Please see below for a response to the Request for Further Information (RFI), issued on 24 May 2024 for the resource consent applications CRC242267, CRC242268 and CRC242269, made by Christchurch City Council (CCC) relating to the Southshore and South New Brighton Inundation Protection Project.

Below is a partial response to Questions 1, 3 and 4 of the RFI. Question 2 is complex and is taking some time to work through and prepare relevant supporting information such as mapping.

Figure 3-2. Southshore erosion protection extents

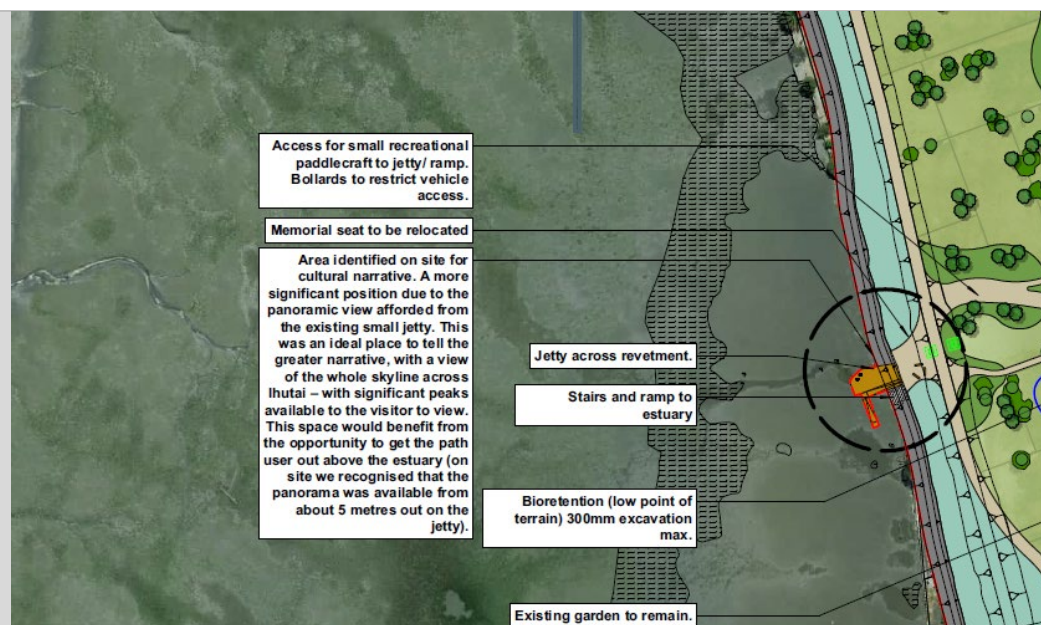
The CRC expert also considers that the wave and water level combination used in the design process is conservative, and particularly so when viewed over short timeframes of the design life of the structures. They also conclude that if a conservative combination of these factors has been used and has found that a cobble beach will provide sufficient protection against coastal erosion for the next 20 years in the South New Brighton Park area where the combination of water, wave and river channel processes are likely to be greatest within the estuary, the CRC expert can see no reason from a coastal process and hazard perspective why a 'harder' engineered rock revetment is required for the majority of the Southshore estuary shoreline. The CRC expert, therefore, considers that a slightly 'softer' engineered cobble beach along the Southshore estuary coastline would provide sufficient protection against coastal erosion for this area.

- c. *Please provide justification for the 'harder' engineered rock revetment along Southshore as a cobble beach has been found to provide an appropriate level of protection against coastal erosion in Southshore.*

We have assumed this question relates to the rock revetment portions between Godwit Street and Kingfisher Lane and approximately 96A Rockinghorse Road to approximately 168 Rockinghorse Road (See Figure 3-2 of the Design Report, reproduced adjacent).

Across the project, a combination of rock revetment and cobble beach has been selected. Cobble beach was selected for areas where local conditions result in lower erosion risk. Rock revetment was selected for areas where there is greater evidence of erosion occurring. Additionally, rock revetment is proposed for sections where there are space constraints which could otherwise result in impacts on existing ecological habitats or the need for increased reclamation / encroachment into the coastal marine area.
